PROJECT: TTU TRACK AND FIELD
SBC# 364/011-05-2025
BAA Project Number 25007
Cookeville, Putnam County, Tennessee

SUBJECT: Addendum No 1

- 03 BUILDING ELEVATION
SOUTH

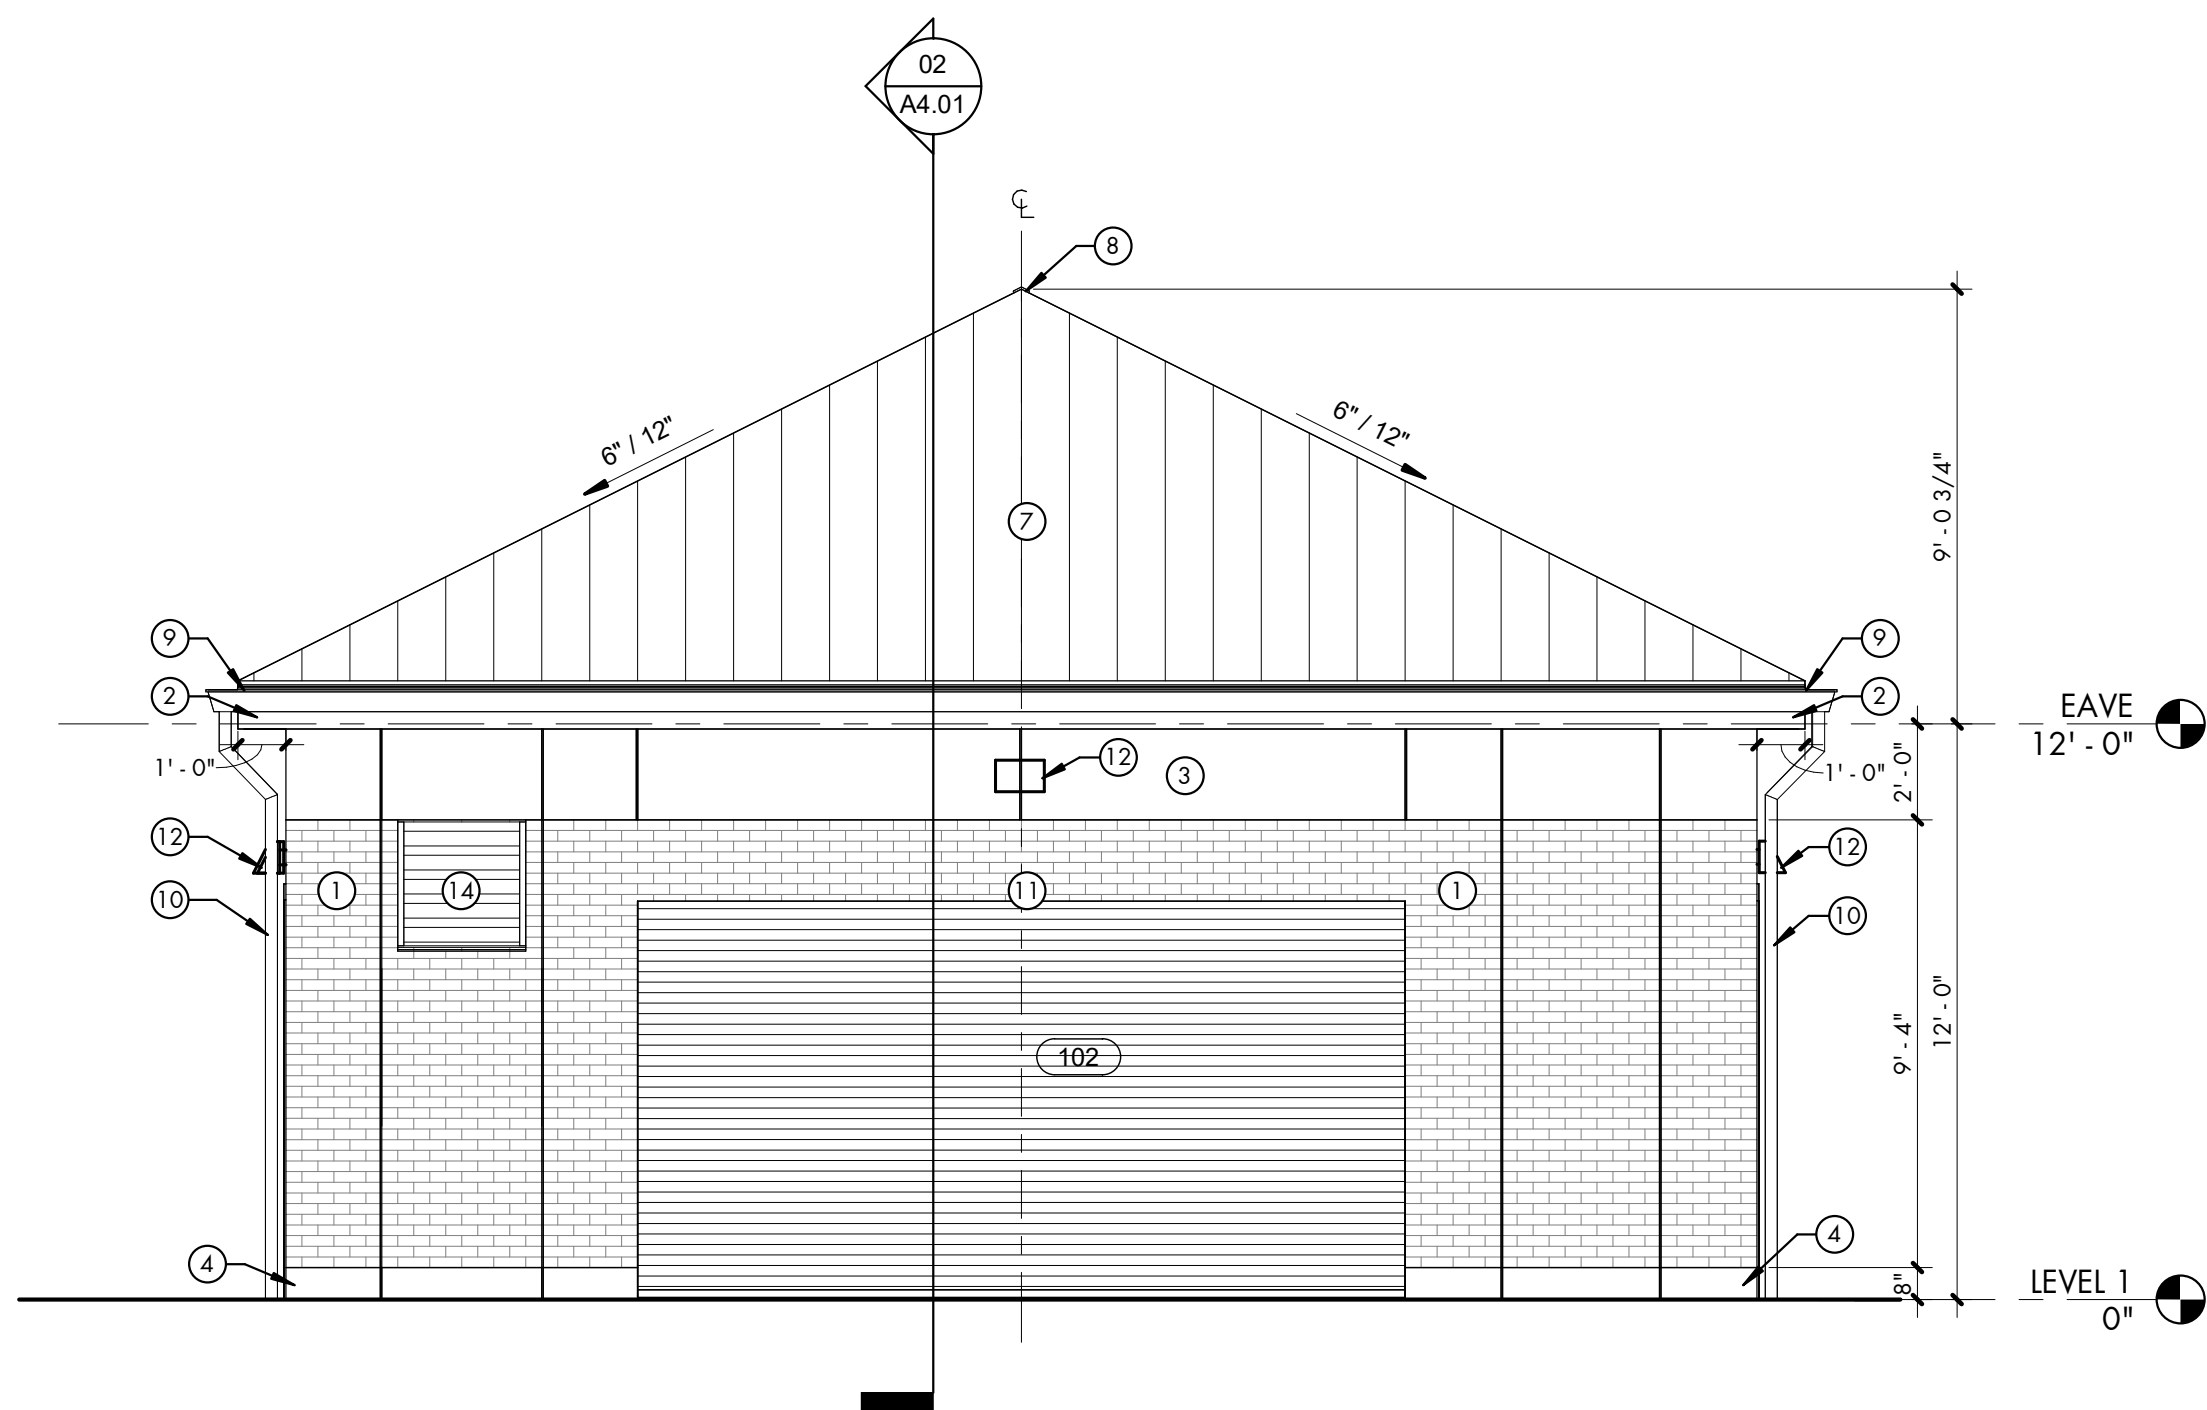
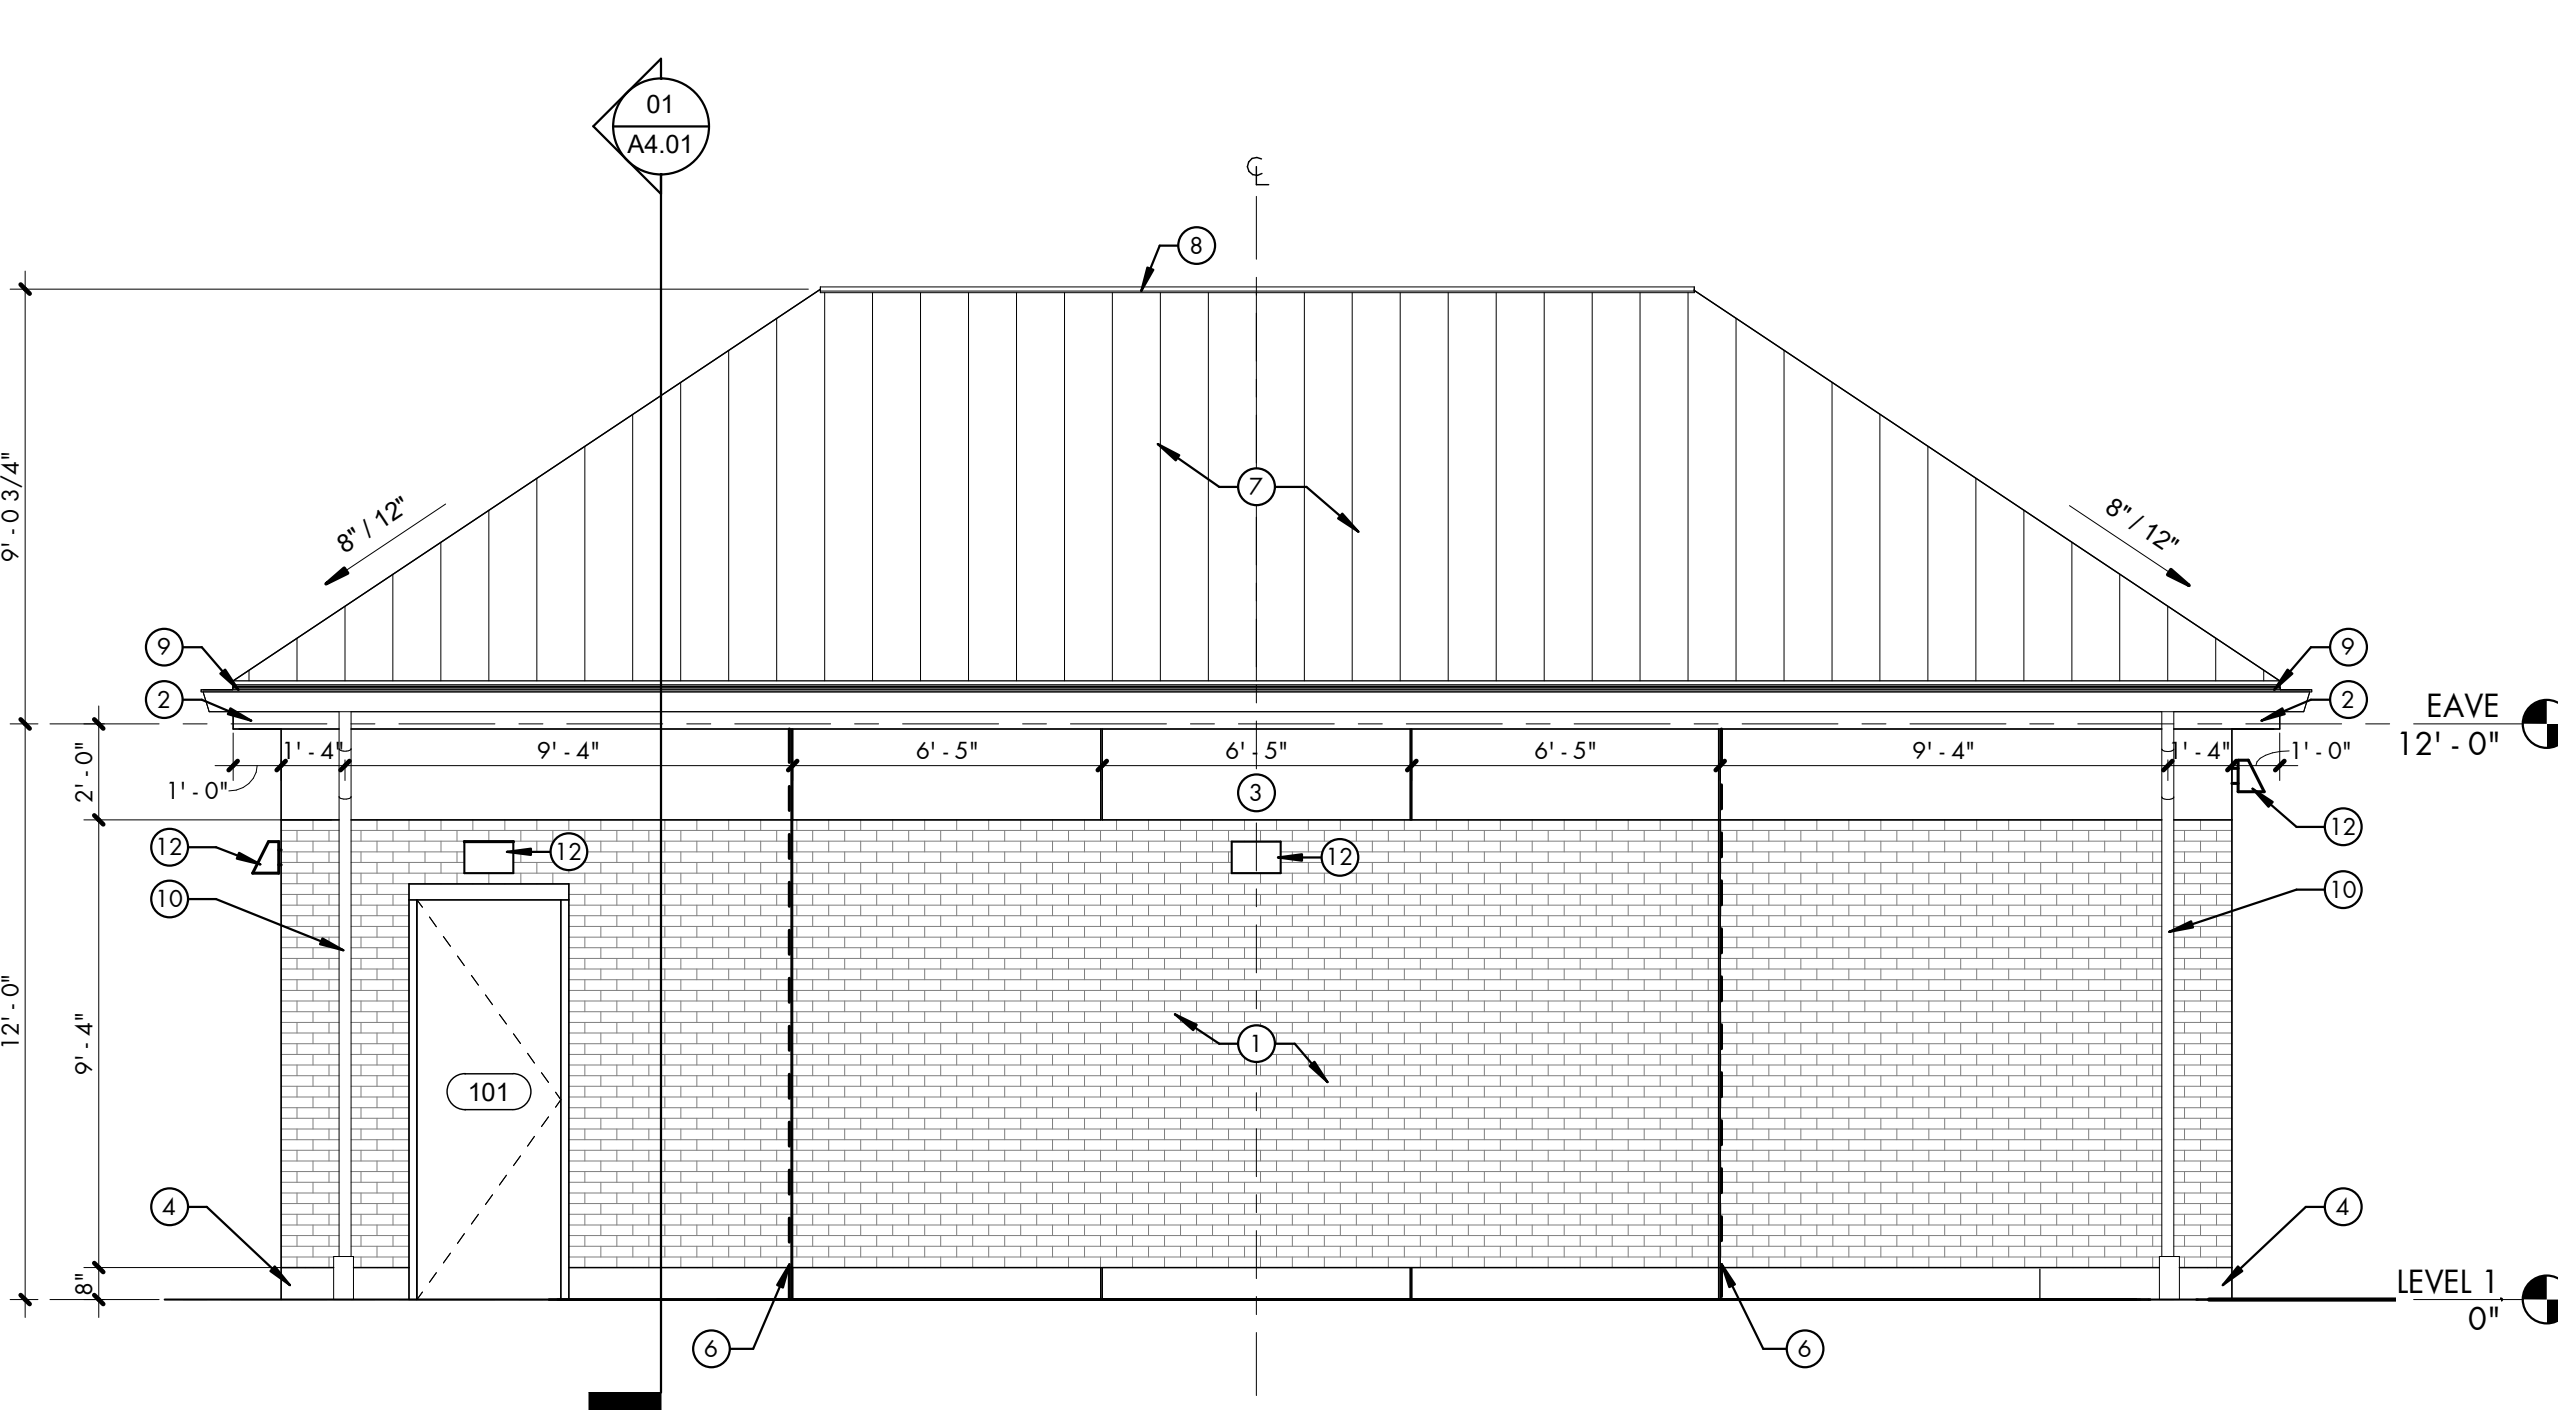
Answer: The building shall match the ACME Engineering Building. The brick specified for ACME was Meridian Brick Company, full range, sand face, face set ACME M/S Windsor Park Velour. Refer to the updated coded notes on Sheet A3.00.
